SB, Rebuild kit, KV9/12, 2021-04

The newly introduced K1270 II does not fit the older KV9/12. For this reason the KV9/12 has been upgraded.

Figure 1: Old and new bracket.

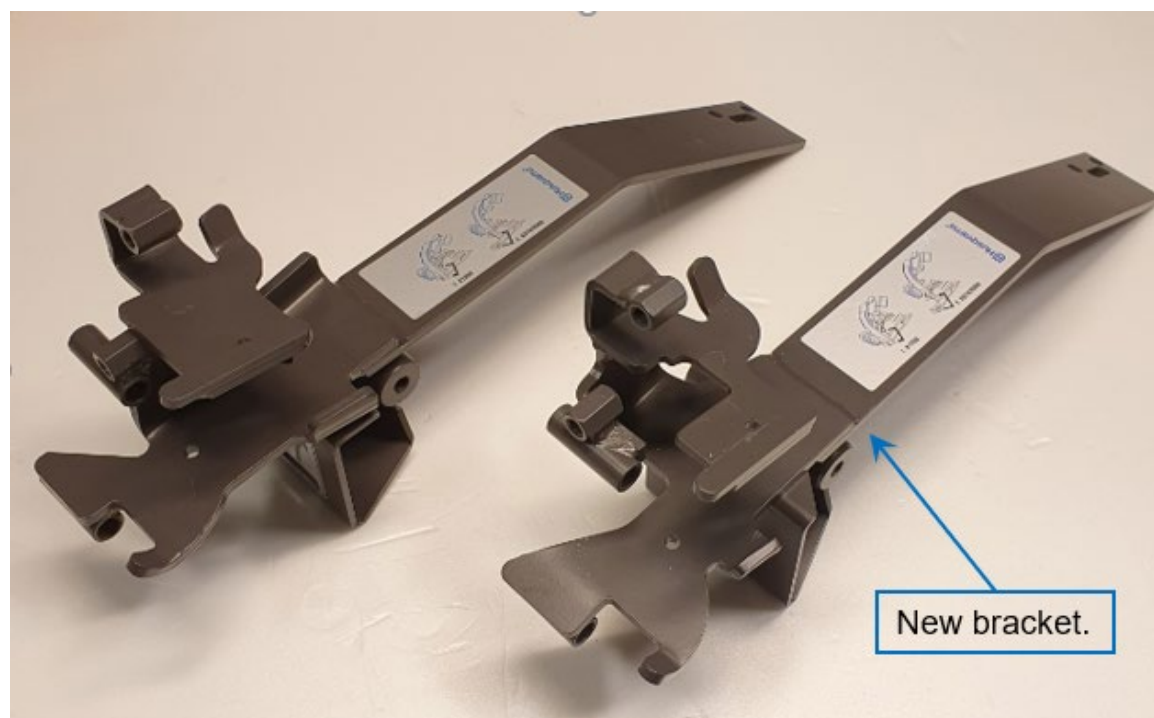
Due to the new 1270 II Fuel Tank, an update of the welded bracket that holds the machine is needed. Below is an instruction how to rebuild the KV using the upgrade kit.

To use a new K1270II on an old KV9/12, you will need an upgrade kit.
